Zoning Staff Report

Case Number: ZC-22-025

Site Location: 1025 W. Beach Street

Proposed Use: Car Wash

SHAMMY'S CAR WASH
 ZONING CASE NO. ZC-22-025
 WEST BEACH STREET
 CITY OF FORT WORTH
 TARRANT COUNTY, TEXAS
 LEE SUBDIVISION ADDITION - LOT 2R, BLOCK 1

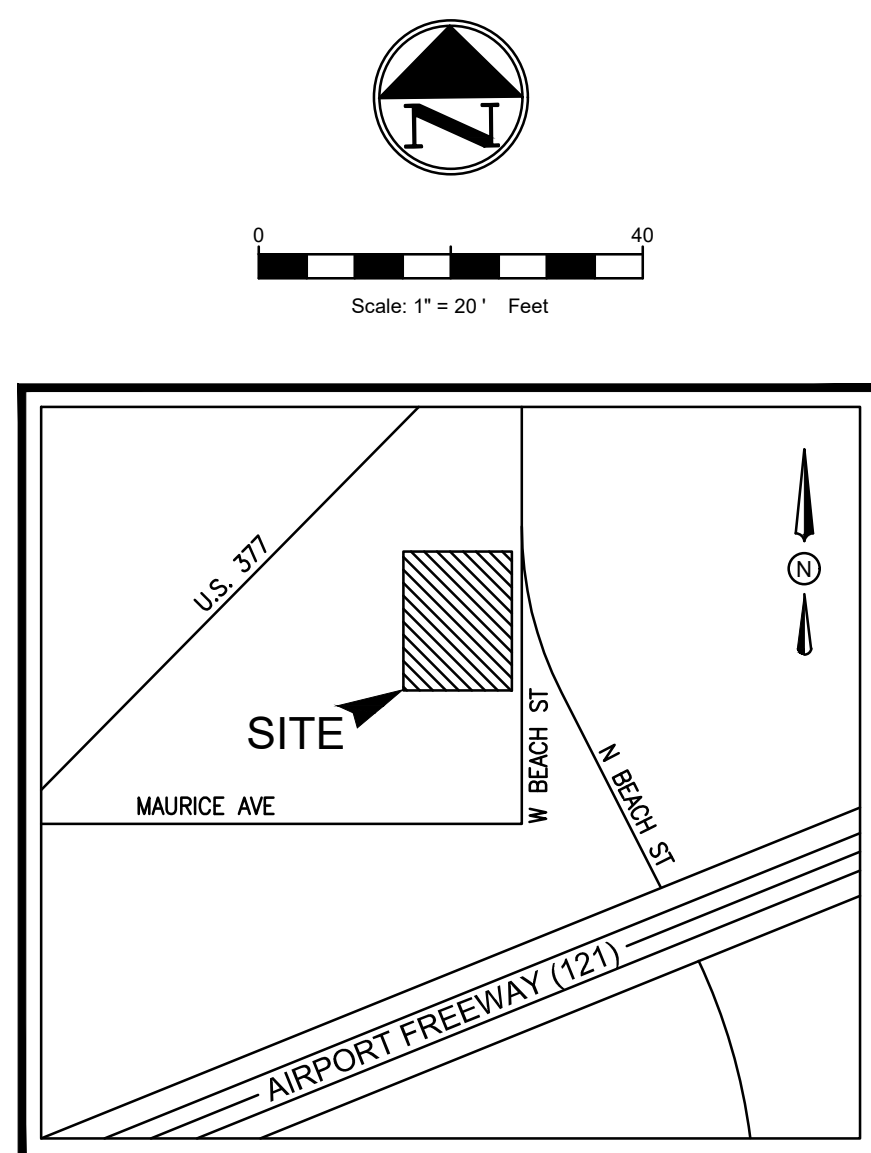
1. The car wash building setback is required to be 100 feet, as per Sec. 5.108, instead of the approximately 65 feet shown. **This item is requesting a development waiver.**
2. A 6-ft minimum solid screening fence is required along the western property line, which abuts a residential district, as required in Sec. 5.108. Since the western property also contains a floodway easement, the solid fence cannot be in this easement. **This item is requesting a development waiver.** The fence along the western property line will need a utility easement encroachment agreement.
3. The access easement and drainage easement overlap in the northeast corner. Generally, the surface material of these two easements is not the same.
4. Note the land use and zoning of the surrounding properties to the east.

- FYI: an accepted drainage study is required prior to platting, infrastructure review, grading permit issuance, and building permit issuance.
- FSR Acceptance required and FDP issuance required prior to grading and building permit issuance.

- CITY GENERAL NOTES**
- THE CAR WASH BUILDING SETBACK IS REQUIRED TO BE 100 FEET, AS PER SEC. 5.108, INSTEAD OF THE APPROXIMATELY 63.7 FEET SHOWN. THIS ITEM IS REQUESTING A DEVELOPMENT WAIVER.
 - A 6-FT MINIMUM SOLID SCREENING FENCE IS REQUIRED ALONG THE WESTERN PROPERTY LINE, WHICH ABUTS A RESIDENTIAL DISTRICT, AS REQUIRED IN SEC. 5.108. SINCE THE WESTERN PROPERTY ALSO CONTAINS A FLOODWAY EASEMENT, THE SOLID FENCE CANNOT BE IN THIS EASEMENT. THIS ITEM NEEDS A DEVELOPMENT WAIVER.
 - ALL PROVIDED LIGHTING WILL CONFIRM TO LIGHTING CODE.
 - ALL SIGNAGE WILL CONFORM TO ARTICLE 4, SIGNS.
 - THE PROJECT WILL COMPLY WITH SECTION 6.301, LANDSCAPING, WITH EXCEPTION OF THE DEVELOPMENT WAIVERS NOTED ABOVE.
 - THE PROJECT WILL COMPLY WITH SECTION 6.302, URBAN FORESTRY.
